PG160-B02

8GB GDDR6, 256b, X16
Tall DVI-D + USBC/DP + DP + HDMI/DP + DP

MS-V375

Page27: PS: 5V

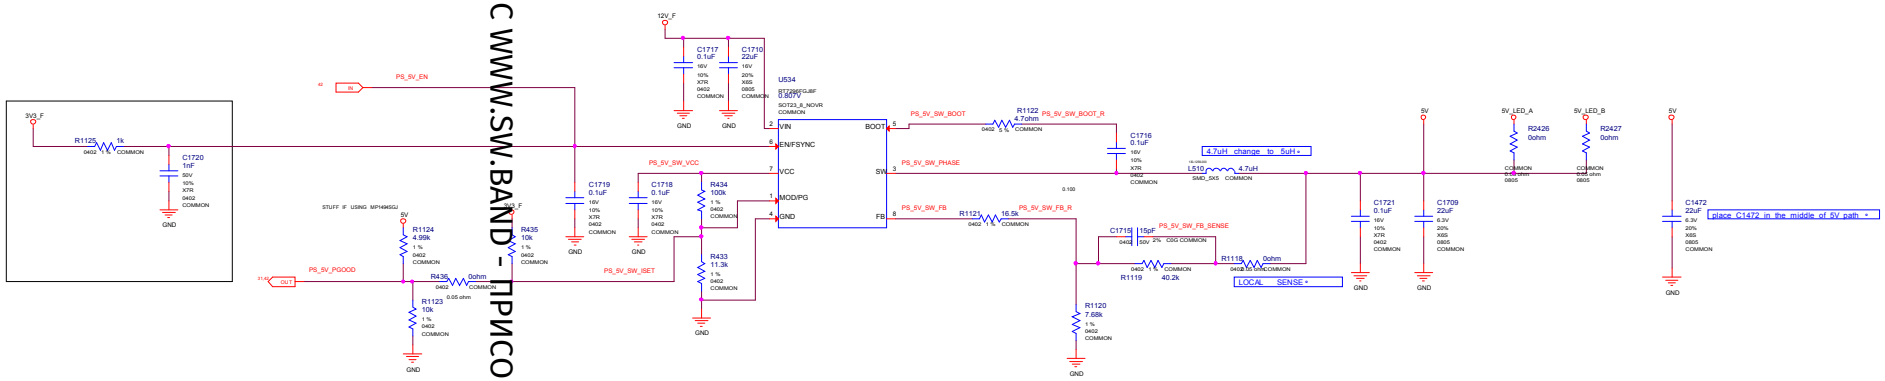
1 L510 P/N L04-0507010-L65 / footprint : CHK_S2_5_4X5_23
2 delete colayout PWM ouput choke.
3 unused RTD3 delete Buck-Boost regulator.

Page28: PS: PEXVDD

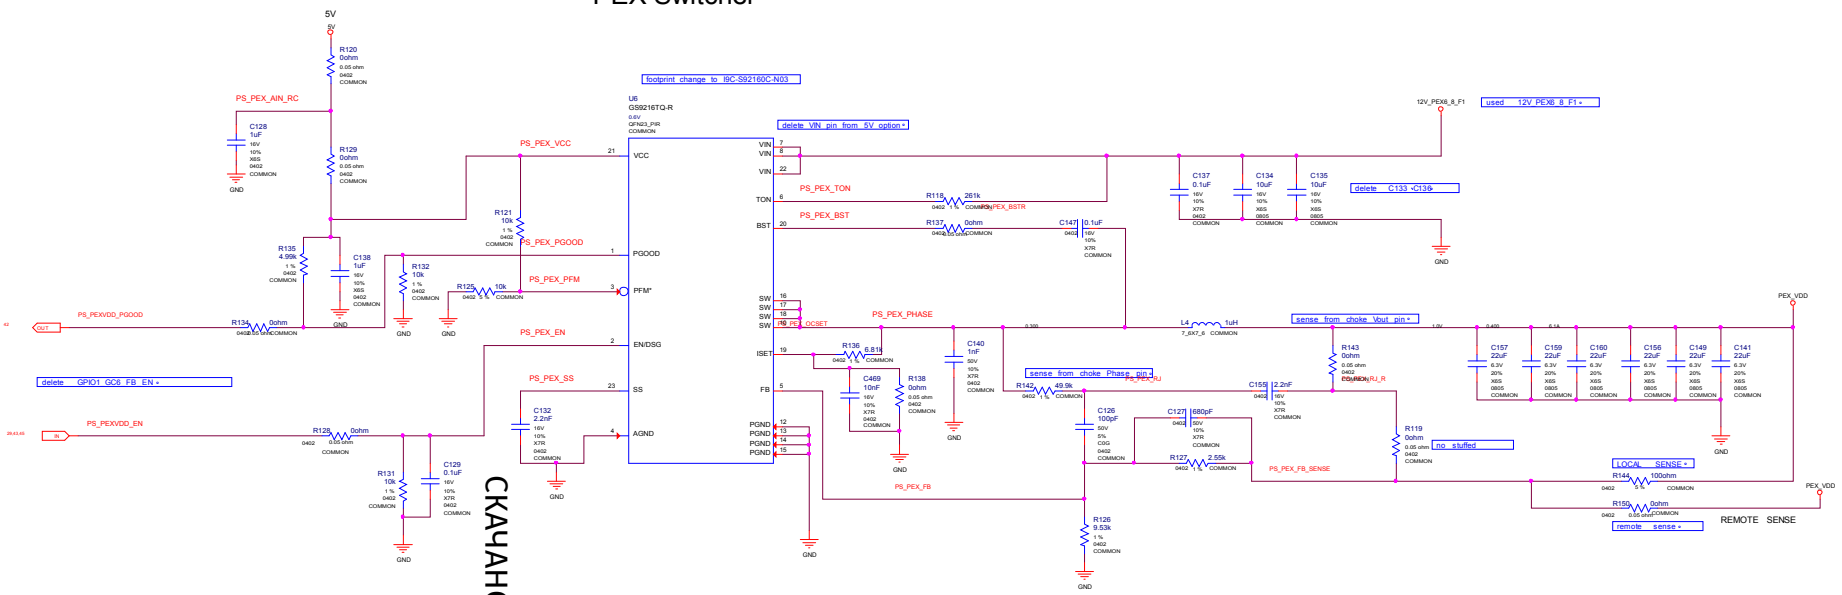
1 L4 PN L04-010740-L65 / footprint : CHK_S2520-3X6_61
2 delete colayout PWM ouput choke

Page30: PS: FBVDDQ PH2

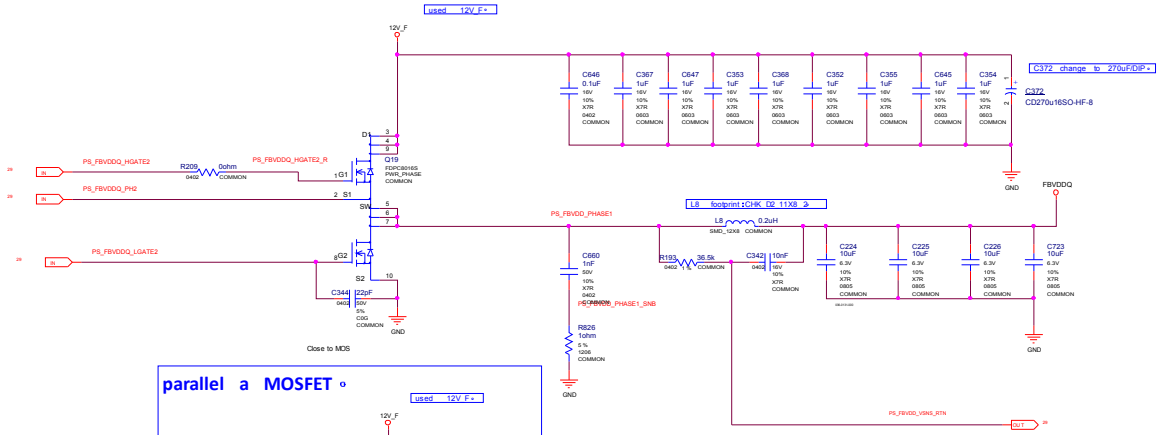
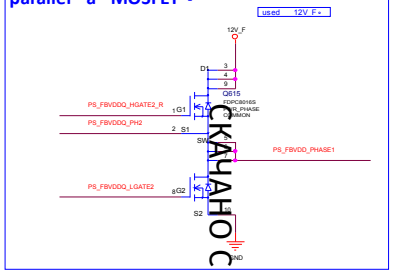
delete RTD3 backdrive

parallel a MOSFET

MICRO-STAR INT'L CO.,LTD		
MS-V375		
Size: Custom	Document Description: PS: Inputs, Filtering, and Monitoring	Rev: 4.0
Date: Friday, November 09, 2018	Sheet 37 of 54

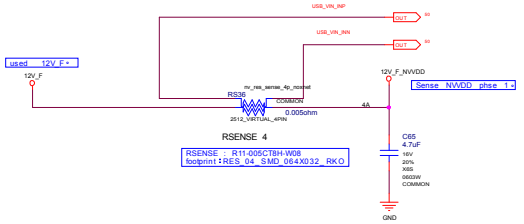
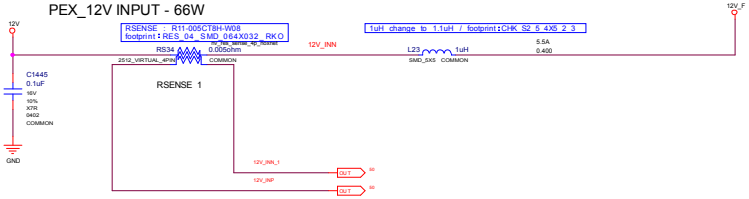
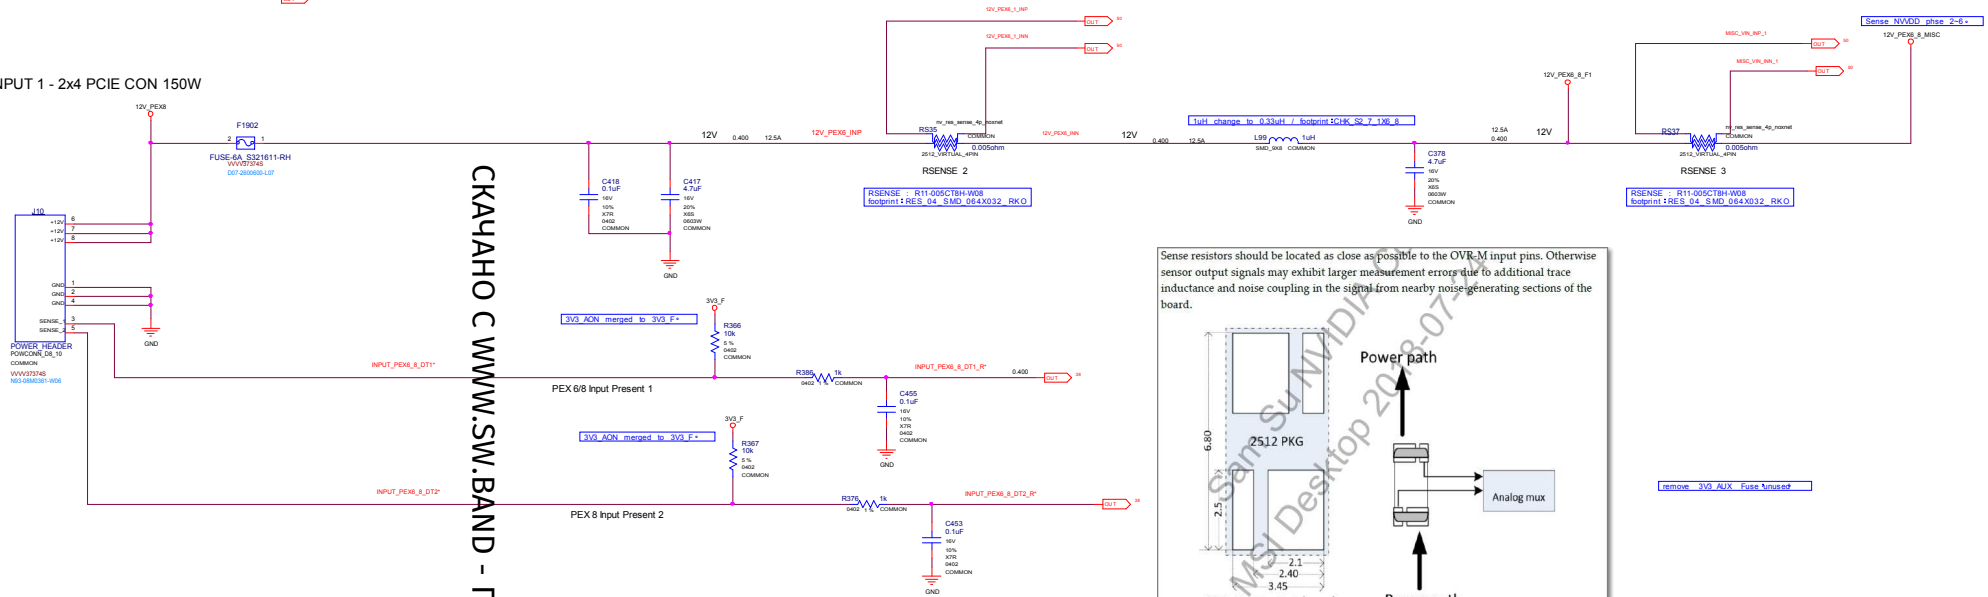
1 changed EXT 12V 8pin PN and footprint
2 add EXT 12V 8pin Fuse
3 delete unused parts
4 RSENSE 3 change to sense NVVDD PEX 12V
5 RSENSE 4 change to sense NVVDD EXT 12V
6 change RSENSE parts and footprint

remove 3V3_AUX Fuse *unused*

12V CURRENT STEERING (UNDER POWER BOOT):

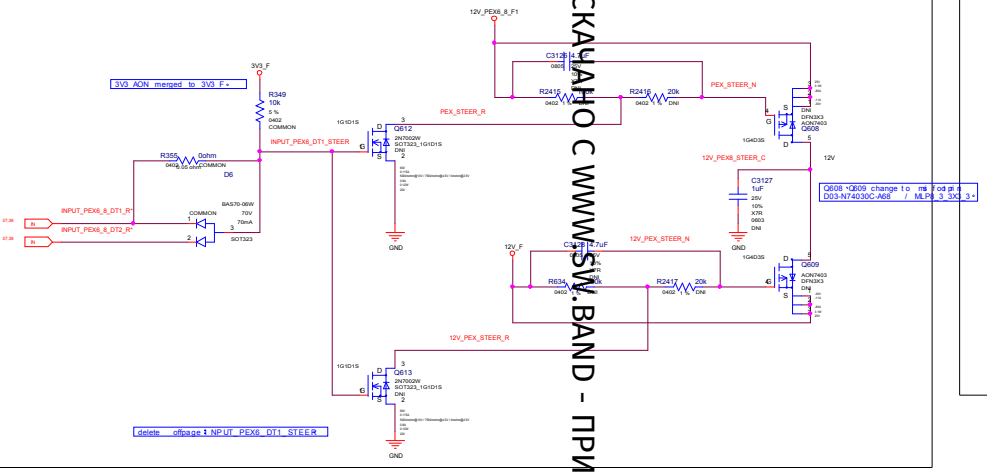
copied 12V CURRENT STEERING from V373-2.0 and BOM stuff ed

Page44: SEQUENCE:Voltage Monitor

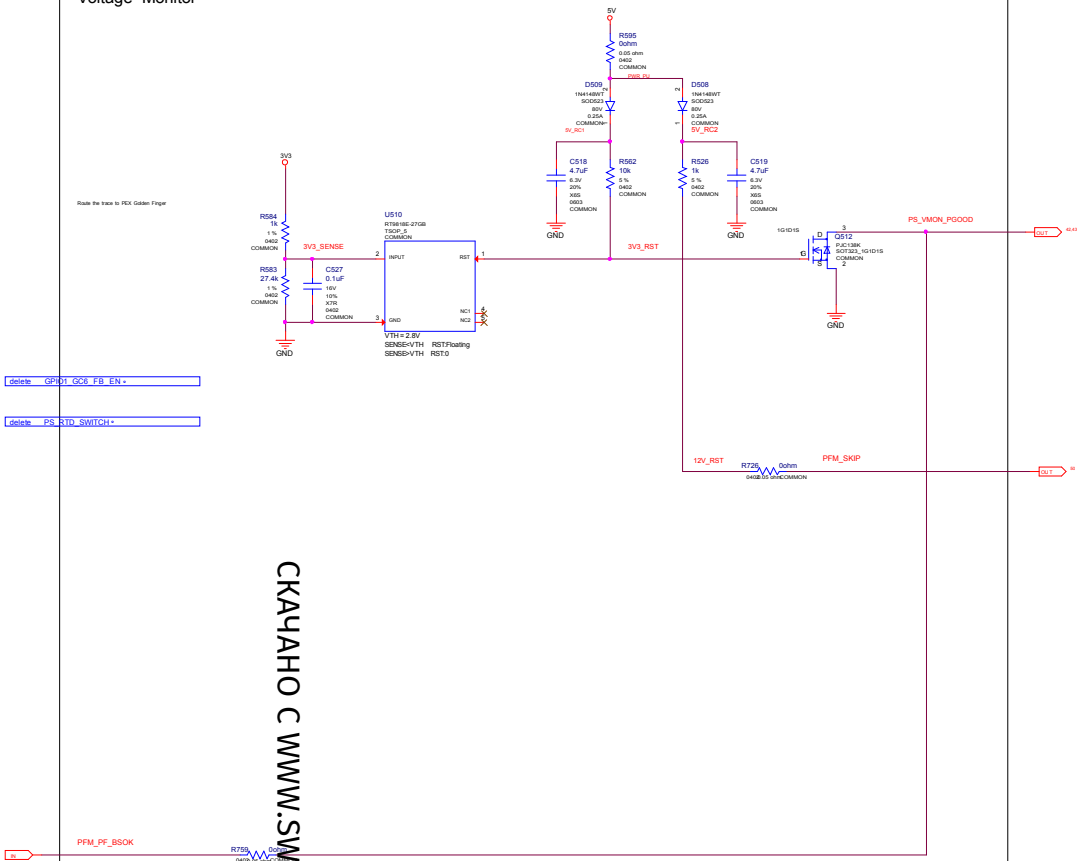
delete unused parts ◦

Page49: DUAL FAN

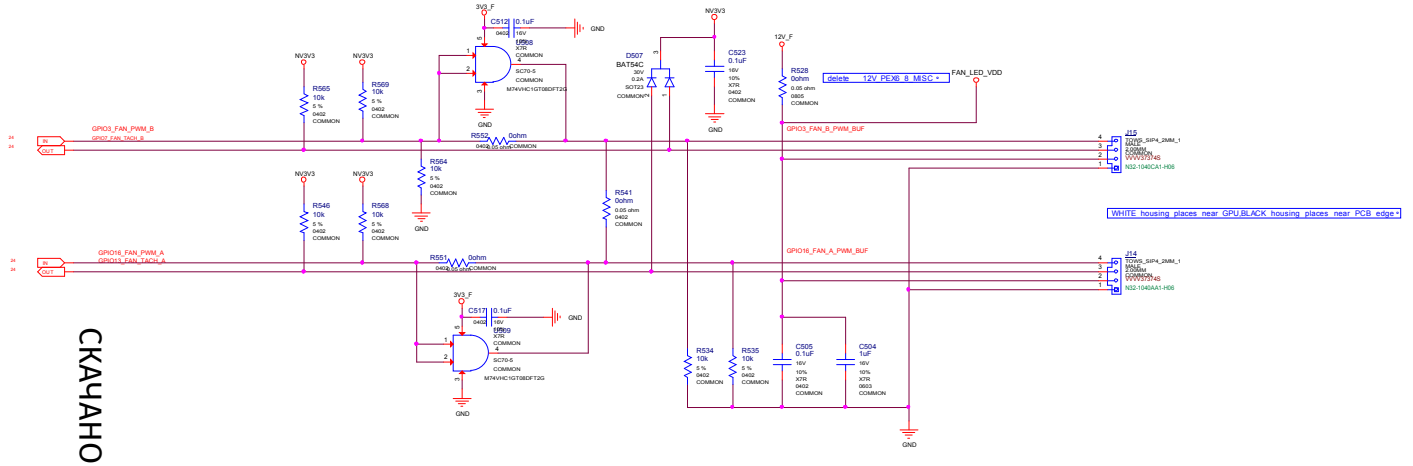
copied V373-2.0 housing PN and footprint ◦
